Urgent: Field Safety Notification FSN20149997

Follow-up action for the Application Instrument of Sternal ZipFix™: Changes in the Surgical Technique Guide

Part Description	Part Numbers	Lot numbers
Application Instrument for Sternal ZipFix™	03.501.080	All 1st generation Application Instruments (Lots prior to 8100630)

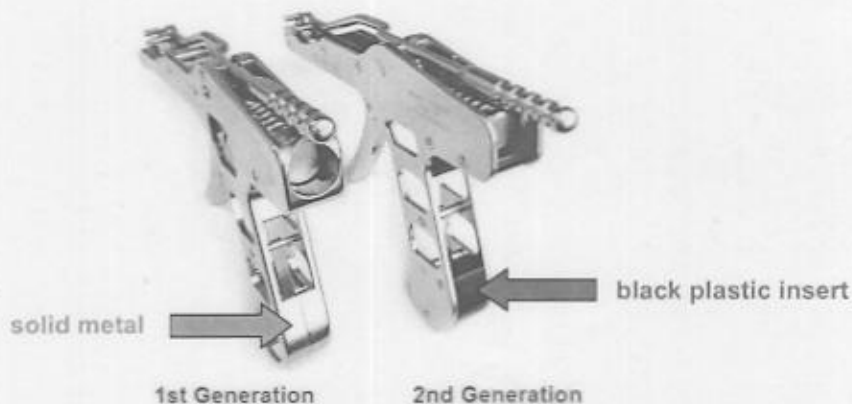
Reason for notification: While the Surgical Technique Guide includes a precaution that the trigger must be released before and during cutting and that no cutting should take place under tension, when using the 1st generation Application Instrument for Sternal ZipFix™, it is possible to cut the implant while the tensioning trigger is being squeezed (known as being cut under tension). This allows the ZipFix™ implants to become overly tensioned and possibly cut.

NOTE: This issue applies to the 1st generation Application Instrument only. The 1st generation instrument is distinguishable by the presence of an all stainless steel handle. Please see the figures below for 1st generation and 2nd generation instruments.

If you currently have a 1st generation ZipFix™ Application Instrument you **must** completely release the tensioning trigger before cutting the implant. Additionally, after cutting the implant, return the cutting lever to its originating (locked) position before using the Application Instrument to tension a subsequent implant.
